CTZ-50  
DRAWN BY: [Signature] CHECKED BY: [Signature] APPROVED BY: [Signature]  
 DATE: 5/22/61 DATE: 5/22/61 DATE: 5/22/61  
 INTERNATIONAL CRYSTAL MFG. CO., INC.  
 18 W. LEE, OKLAHOMA CITY, OKLAHOMA

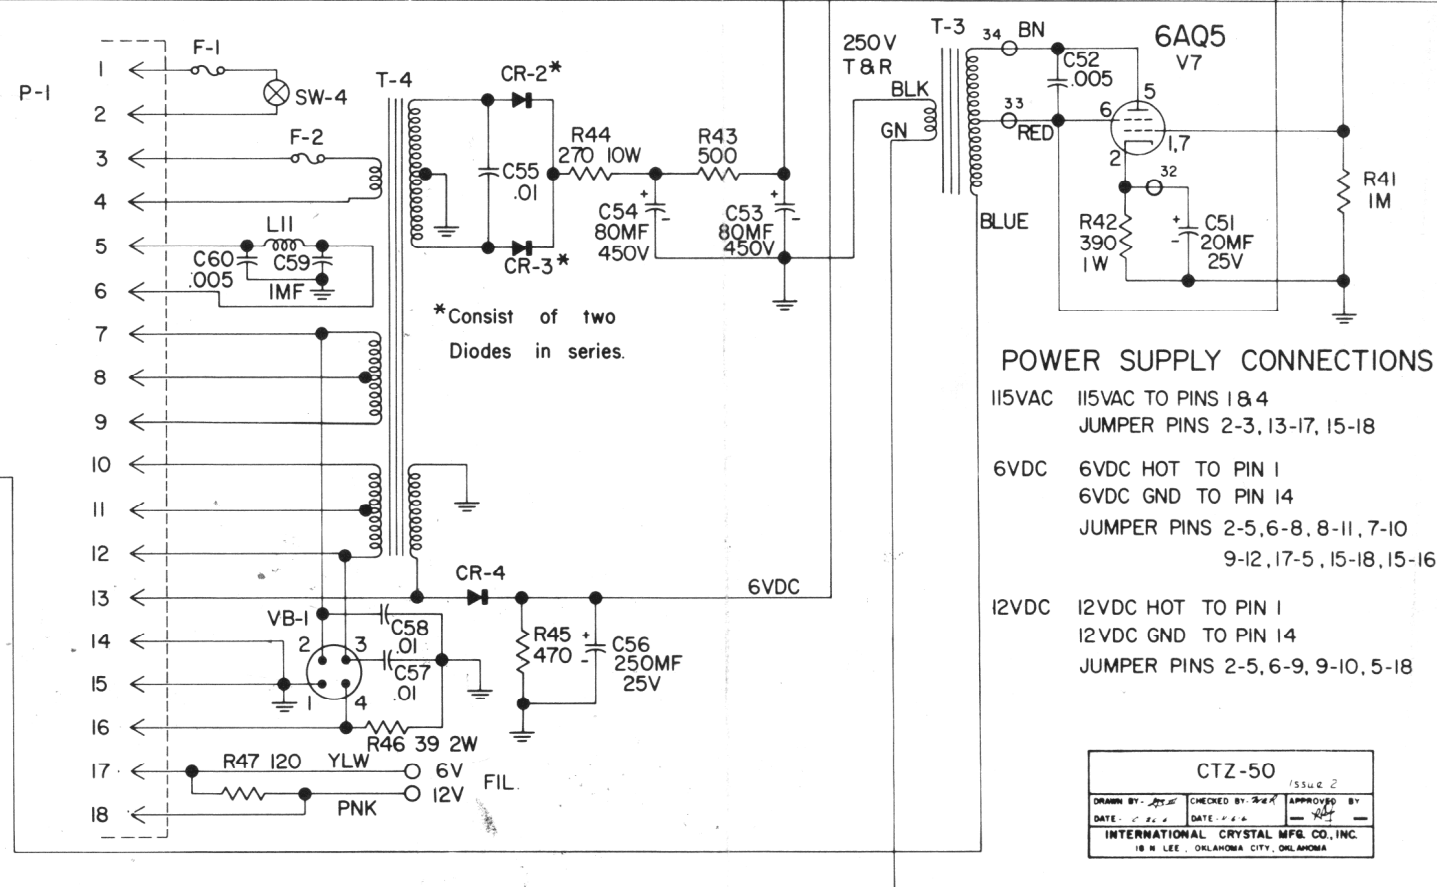
BEGINNING WITH SERIAL NO.	REVISION
7701	C11 CHANGED FROM .02, 500V TO .01, 1000V. 4/26/61
7801	C40 CHANGED FROM .02, 500V TO .02, 1000V. 5/1/61
8269	A 220K, 1/2 W RESISTOR CONNECTED FROM PIN 1 OF V9 TO GND (R57). 5/27/61
8501	C5, C7, C8 & C23 CHANGED FROM .02, 500V TO .005, 500V. L9 CHANGED TO 1500, 1/2 W RESISTOR (R56). 6/6/61
50373	R16 CHANGED FROM 150K TO 27K. R18 FROM 330K TO 39K. C39 & C42 CONNECTED TO PIN 1 OF V5A. R55 ADDED FROM PIN 1 OF V5A TO GND. R21 CHANGED FROM 68K TO 56K. 10/21/61
